Boise Cascade
Engineered Wood Products
Eastern Region Office
 3465 Lawrenceville-Suwanee Road, Suite A
 Suwanee, Georgia 30024-2410
 770-614-4010 1-800-524-7209 toll free

Description: Floor Joist F-J-4(i14486)

Project: Lot 593 Colony
 Address: 98 White Doe Crossing
 City, St: Cameron, NC
 Retailer: Builders FirstSource
 Distributor:
 Date: 8/9/24

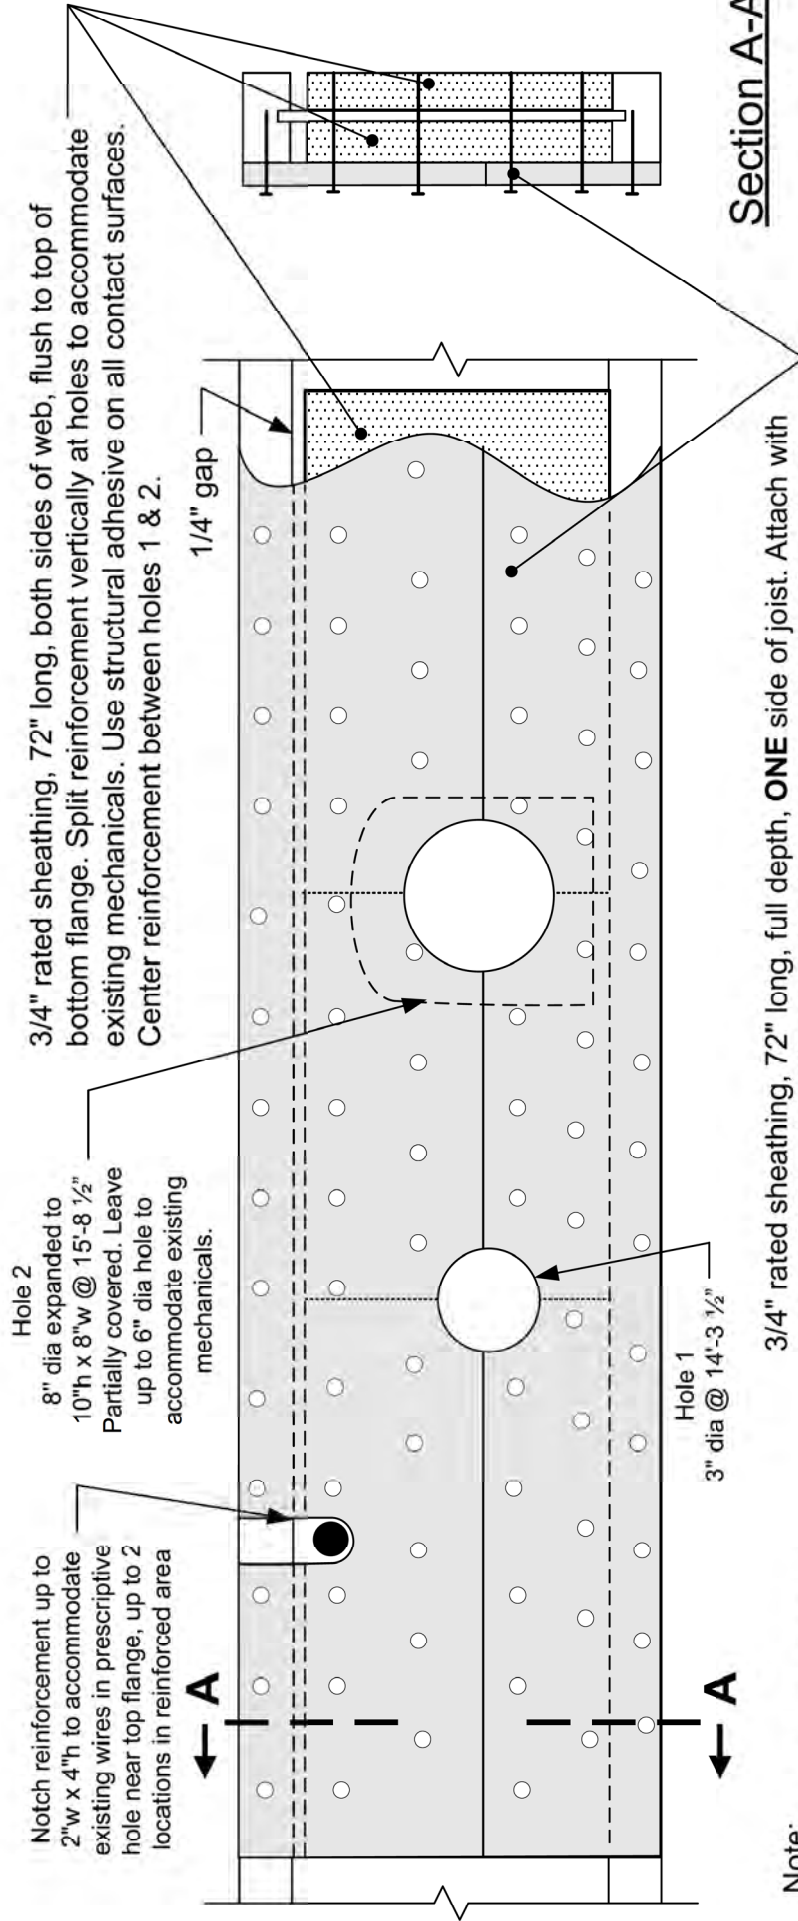
No additional holes allowed in reinforced area.

Hole 2
 8" dia expanded to 10" h x 8" w @ 15'-8 1/2"
 Partially covered. Leave up to 6" dia hole to accommodate existing mechanicals.

Notch reinforcement up to 2" w x 4" h to accommodate existing wires in prescriptive hole near top flange, up to 2 locations in reinforced area

3/4" rated sheathing, 72" long, both sides of web, flush to top of bottom flange. Split reinforcement vertically at holes to accommodate existing mechanicals. Use structural adhesive on all contact surfaces. Center reinforcement between holes 1 & 2.

3/4" rated sheathing, 72" long, full depth, **ONE** side of joist. Attach with 4 rows of 16d nails at 4" on center in web area and 1 row 8d nails at 6" on center in top/bottom flange. Split reinforcement horizontally to accommodate existing mechanicals. Use structural adhesive on all contact surfaces. Center reinforcement between holes 1 & 2.
